**LAND USE APPLICATION SUMMARY**

*Property Location:* 2011 and 2019 Chicago Avenue  
*Project Name:* Community Health/First Care Clinics  
*Prepared By:* Aaron Hanauer, Senior City Planner, (612) 673-2494  
*Applicant:* NLFS 2011, LLC  
*Project Contact:* Rock Solid Companies, Ron Touchette  
*Request:* To allow for the construction of a new clinic.

<b>Variance</b>	To reduce the front yard setback along East 21 <sup>st</sup> Street from 42 feet to 7 feet for off-street parking spaces.
<b>Site Plan Review</b>	To allow for the construction of a new clinic.

1 SITE PLAN  
A1 SCALE: 1" = 20'-0"

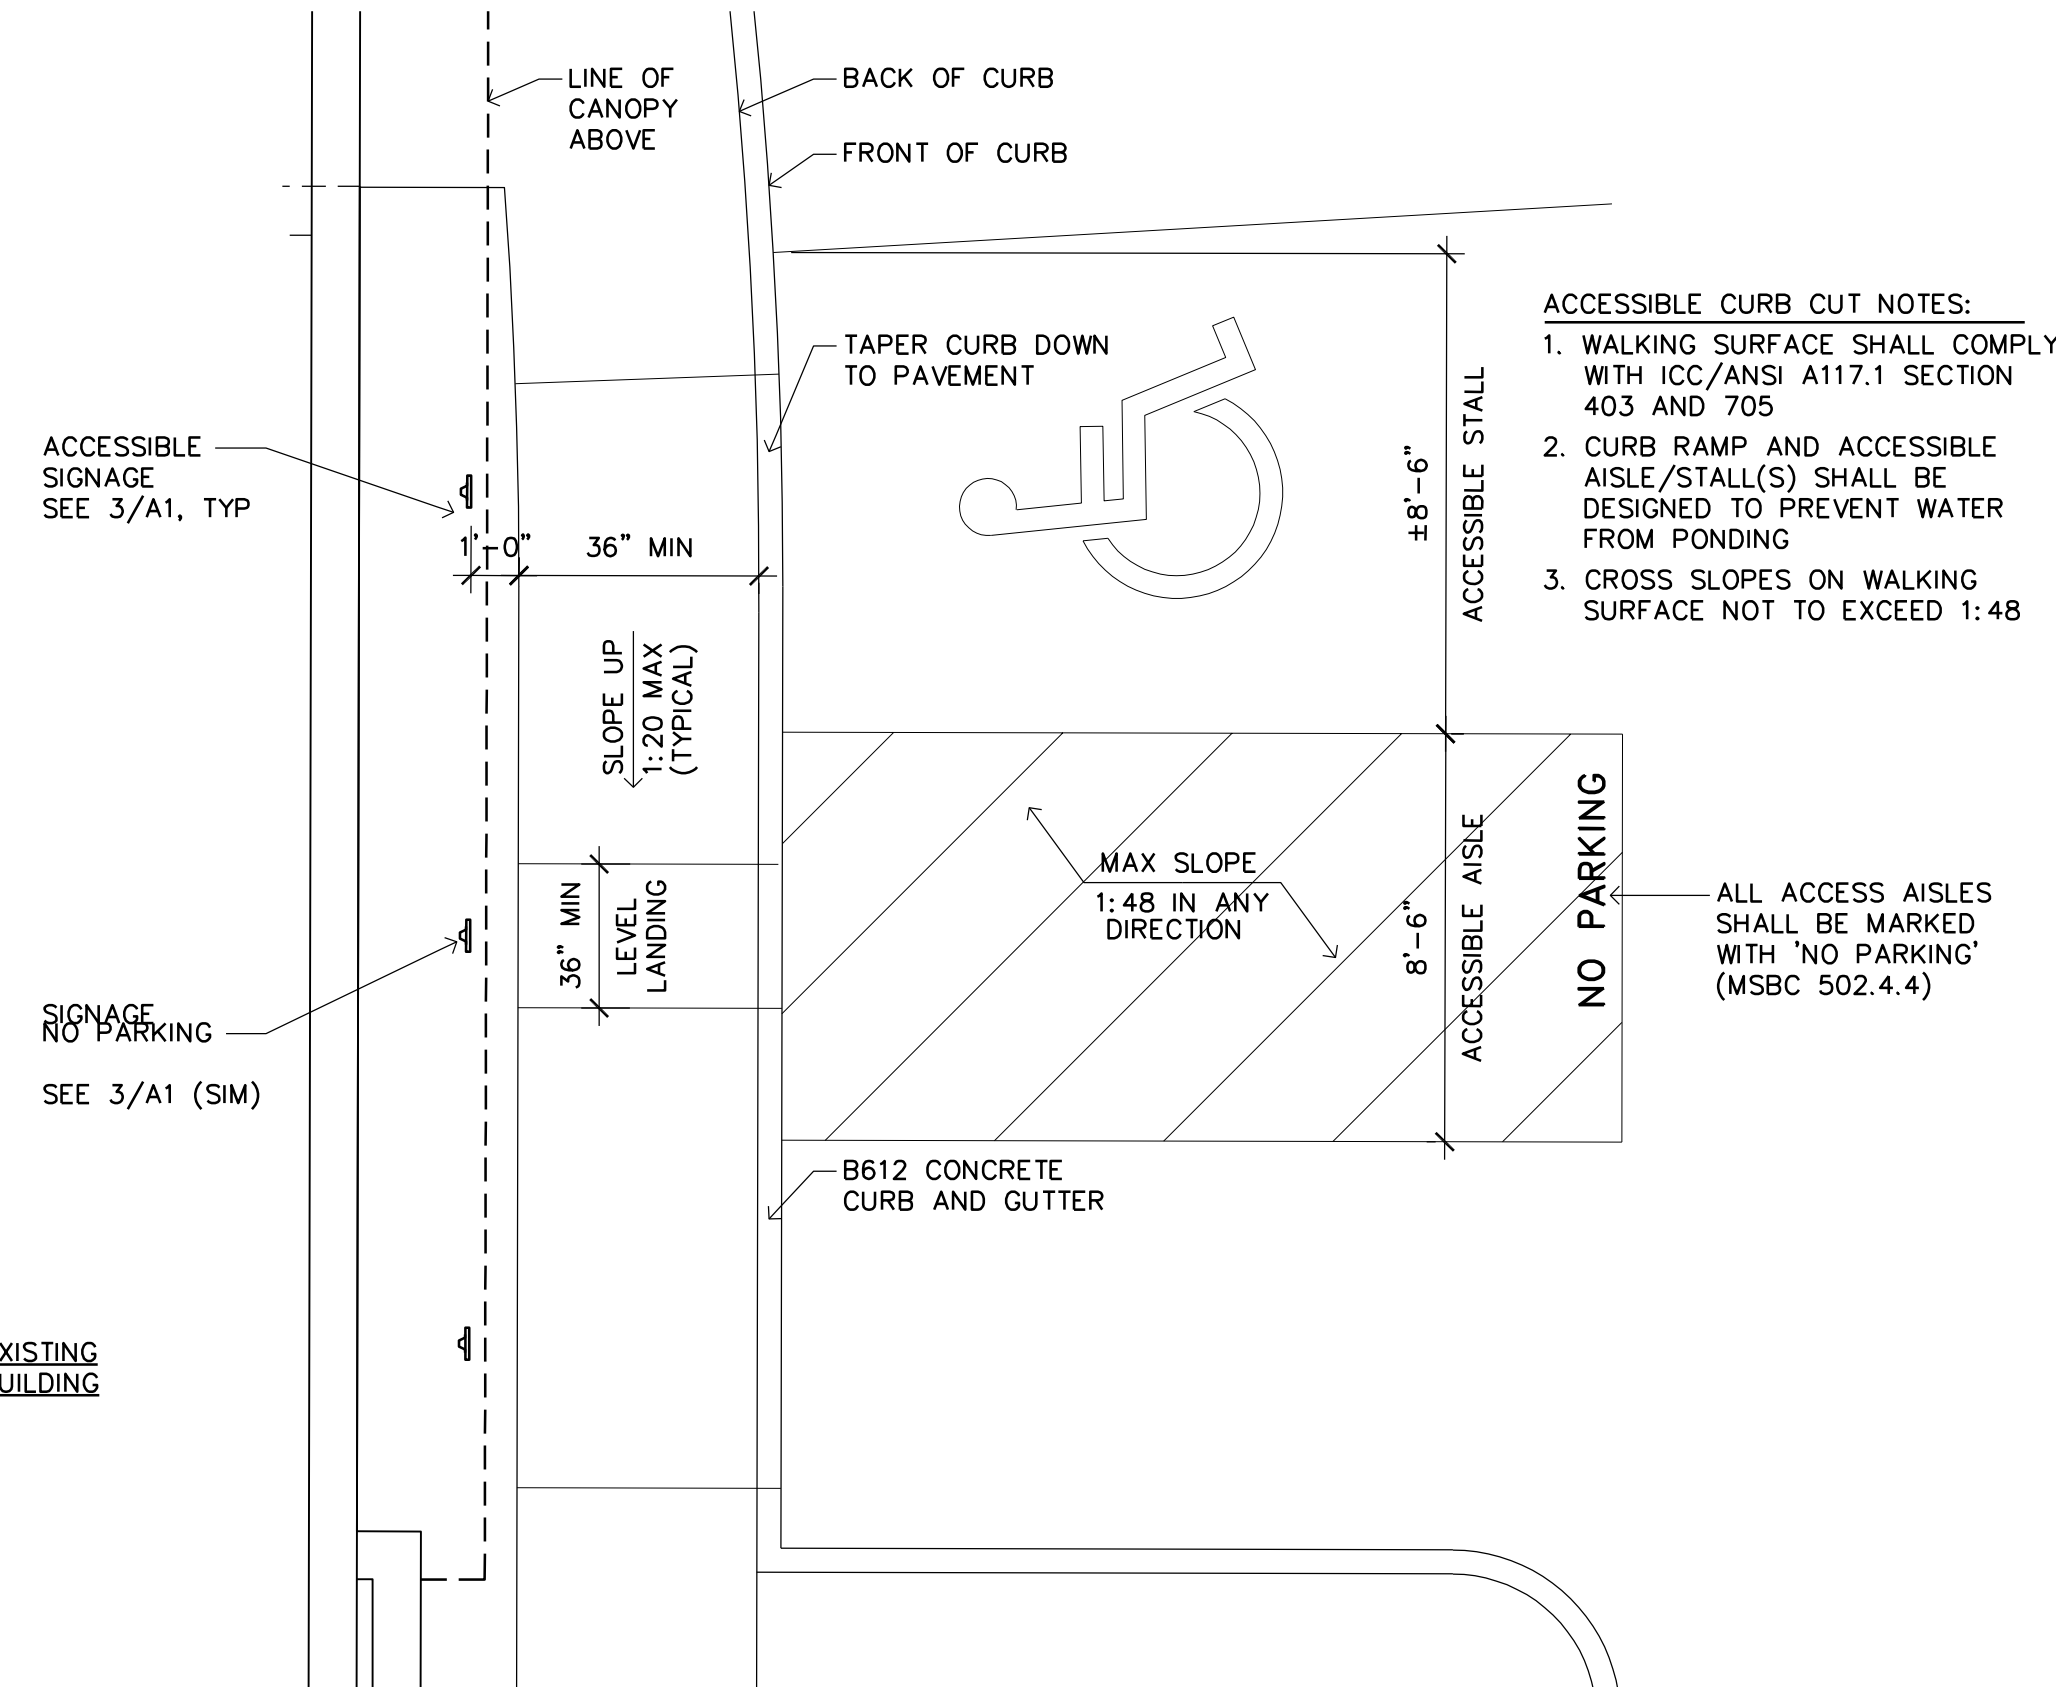
The Department of Community Planning and Economic Development has analyzed the application for a variance to reduce the front yard setback along East 21<sup>st</sup> Street from 40 feet to 7 feet to allow for off-street surface parking spaces, based on the following findings:

As outlined in Section 548.140 – Yard requirements, the project’s front yard setback along East 21<sup>st</sup> Street is established by the front yard setback of the neighboring residential or office residential zoned property. The neighboring site to the east (2000 Elliot Avenue) has a residential building that is setback 40 feet from the East 21<sup>st</sup> Street property line. Therefore, the subject property’s front yard setback is 40 feet for the first 25 feet from the shared lot line with the neighboring Office Residential District. The applicant is proposing to have a row of surface parking spaces that would be 14 feet from the front property line along East 21<sup>st</sup> Street. Practical difficulties exist in complying with the ordinance because of circumstances unique to the property. Given that the project site is a reverse corner lot, the project site has two front yard setbacks (Chicago Avenue and East 21<sup>st</sup> Street). In addition, the 40-foot setback established by the neighboring property to the east is deeper than a typical front yard setback in Minneapolis, especially for a commercially zoned property. The adjacent residential building is oriented toward Elliot Avenue and the proposed parking stalls would not be located in an area that feels or functions like a continuation of the neighboring property’s front yard.

Approving the front yard setback variance request along East 21<sup>st</sup> Street from 40 feet to 15 feet will not alter the character of the immediate area nor be detrimental to the health, safety, or welfare of the general public or of those utilizing the property or nearby properties. As previously noted, the proposed setback will match the setback of the neighboring surface parking area to the east and allow for more landscaping along East 21<sup>st</sup> Street.

- The project would comply with the applicable parking and loading landscaping and screening requirements. However, the parking area abuts a residential district to the east and only has a five-foot-wide yard landscaped yard. Alternative compliance is required.

- The building would meet the applicable yard requirements. However, the off-street parking proposal requires a front yard setback along East 21<sup>st</sup> Street.

Standard	Description	Staff Recommendation
<p><b>Landscaped area for parking abutting a residence district</b></p>	<p>The parking area abuts a residential district to the east and only has a five-foot-wide yard landscaped yard. Alternative compliance is required.</p>	<p>The proposed alternative is consistent with applicable development plans or development objectives adopted by the city council and meets the intent of this chapter. The proposal for a five-foot landscaped yard combined with a hedge of arborvitae will provide adequate screening of the parking area. <u>Staff recommends granting alternative compliance.</u></p>

Recommended motion: **Deny** the variance to reduce the front yard setback along East 21<sup>st</sup> Street from 40 feet to 14 feet and in lieu thereof **Approve** a variance to reduce the front yard setback along East 21<sup>st</sup> Street from 40 feet to 15 feet for parking spaces.

1 WEST ELEVATION  
A3 SCALE: 1/8" = 1'-0"

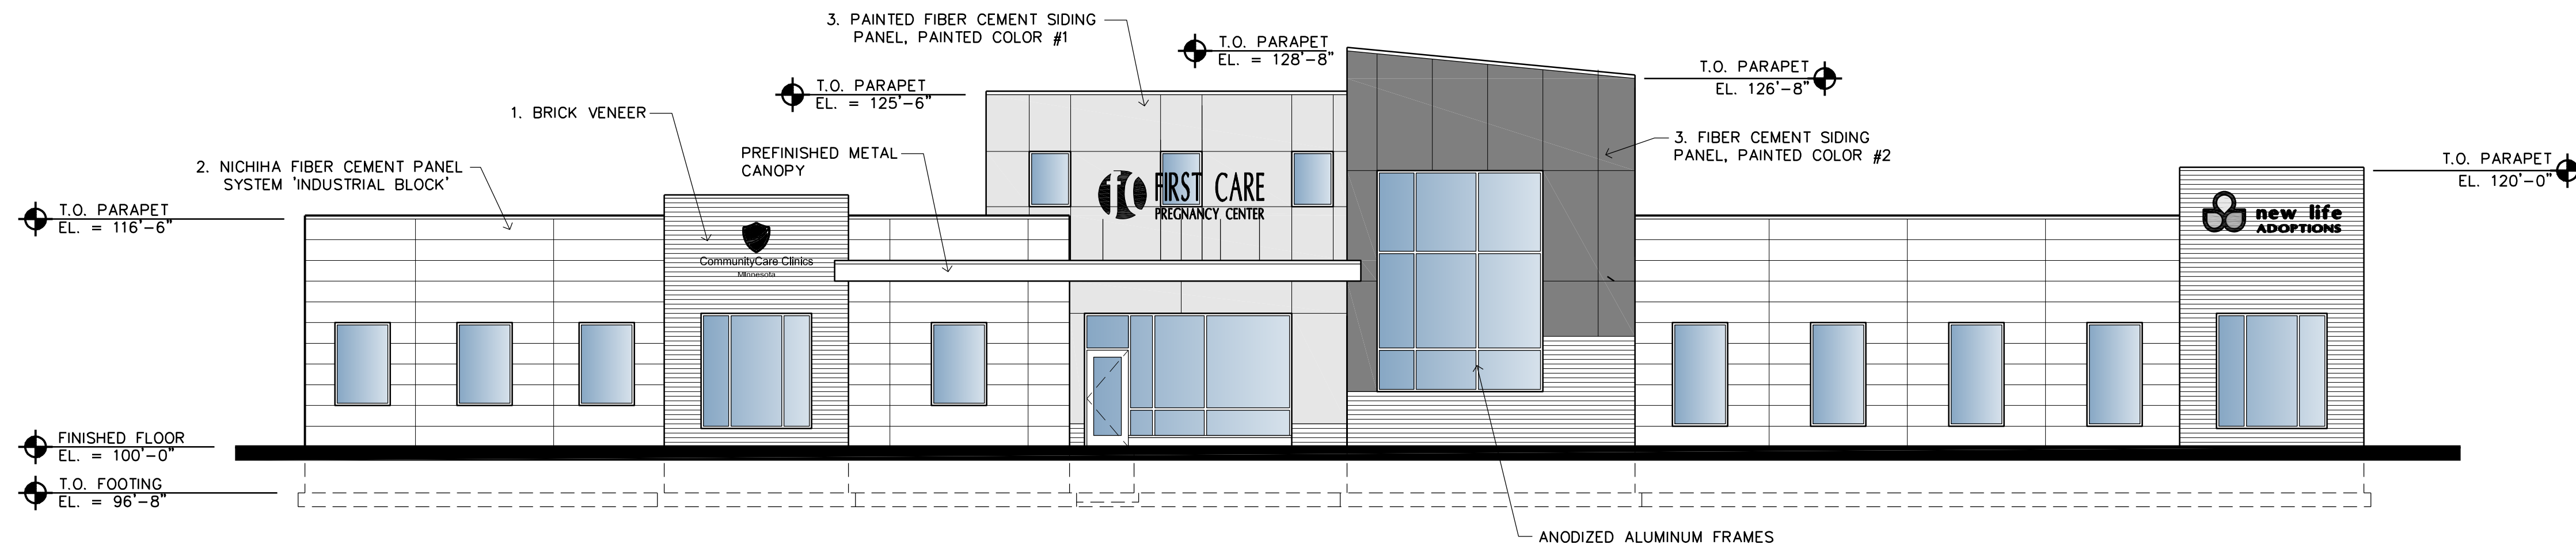
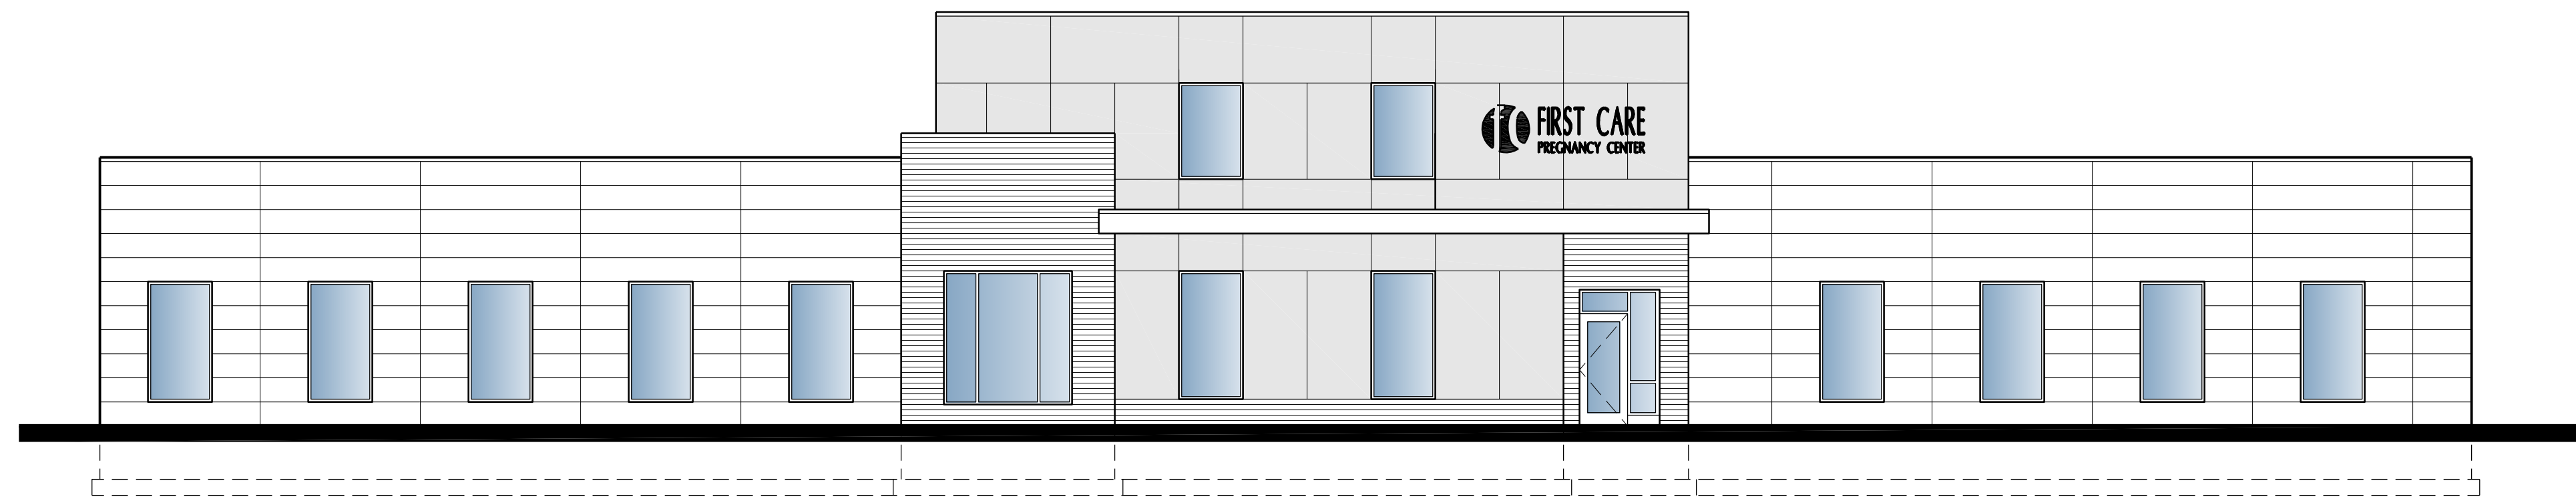
- The applicant is proposing brick, fiber cement greater than 5/8 inches thick, and fiber cement less than 5/8 inches thick as the building’s primary exterior materials. Exterior material changes at a later date may require review by the Planning Commission and an amendment to the site plan review.
- Each elevation would comply with the City’s durability standards for exterior materials, number of exterior materials, and having appearance on the rear and side walls compatible with the front of the building.

Material	Allowed Max	West	South	North	East
<b>Brick (face)</b>	100%	16%	11%	17%	18%
<b>Glass</b>	100%	24%	18%	24%	19%
<b>Fiber Cement (≥ 5/8")</b>	75%	38%	44%	38%	40%

- The proposed project would comply with the minimum window requirements. As a condition of approval to comply with Section 530.120 – Building design, first floor or ground floor windows shall have clear or lightly tinted glass with a visible light transmittance ratio of six-tenths (0.6) or higher.

6. To comply with Section 530.120 – Building design, first floor or ground floor windows shall have clear or lightly tinted glass with a visible light transmittance ratio of six-tenths (0.6) or higher.

1 LANDSCAPE PLAN  
L1 SCALE: 1" = 20'-0"

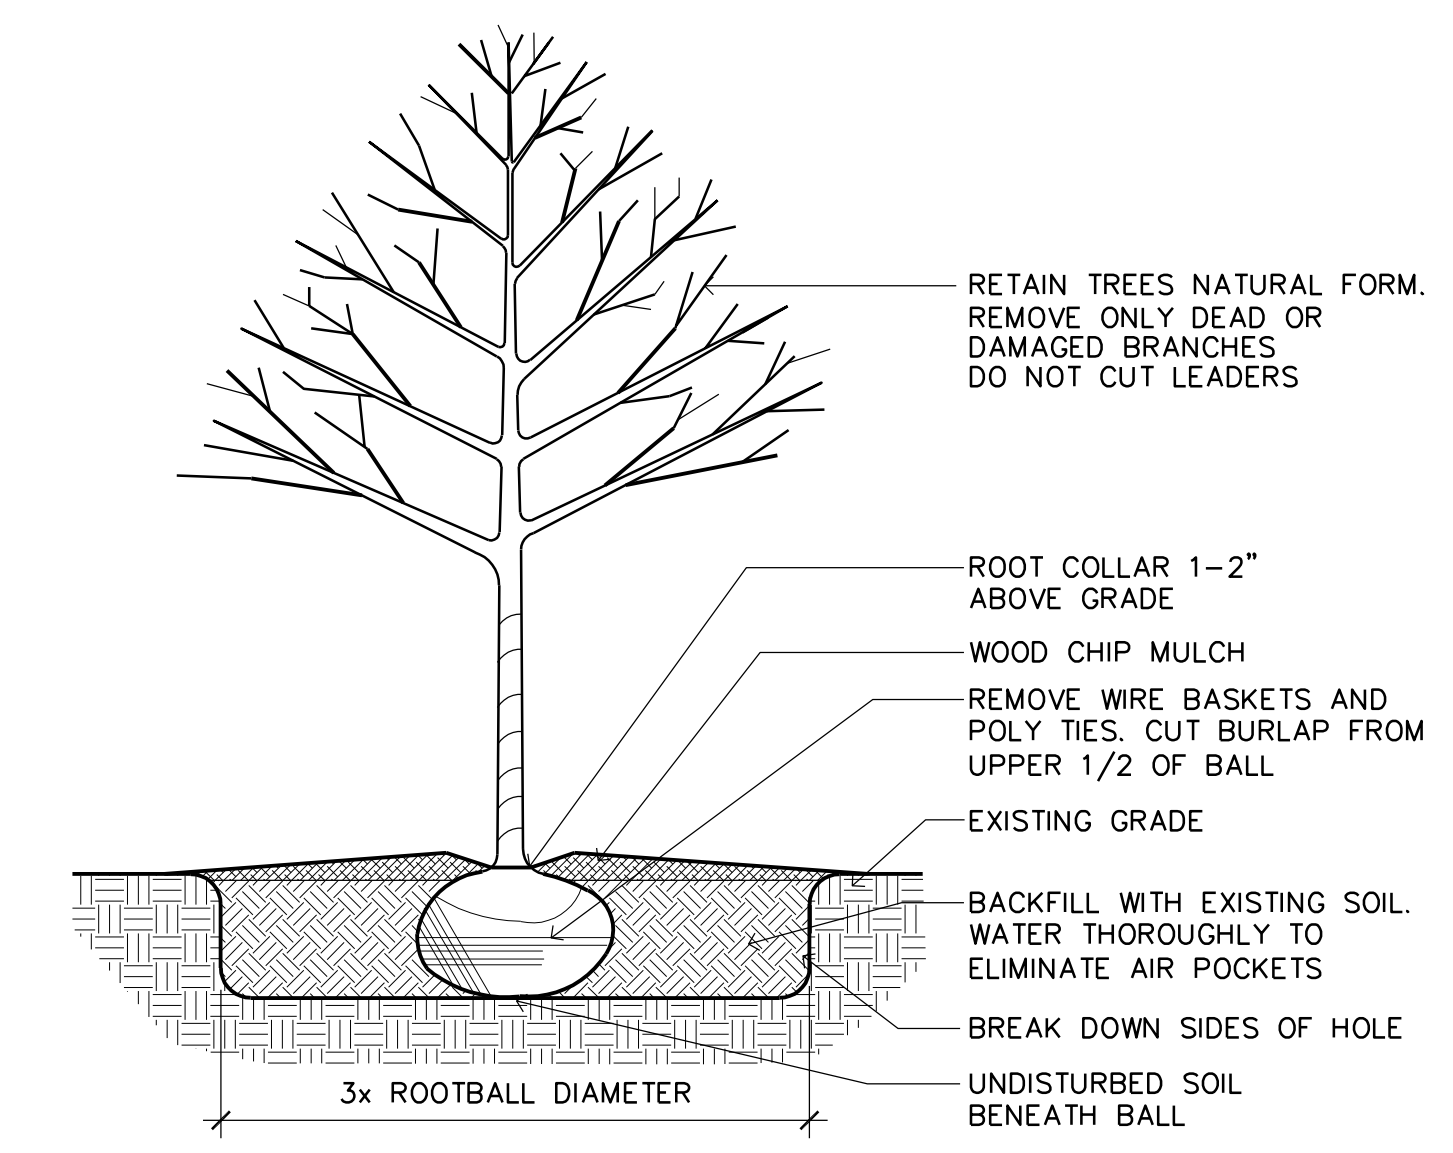
- The project appears to comply with the additional landscaping requirements in sections 530.180, 530.190, 530.200, and 530.210 of the zoning code.
- To comply with Section 530.180 – Landscaping of other area, no rock mulch is allowed.
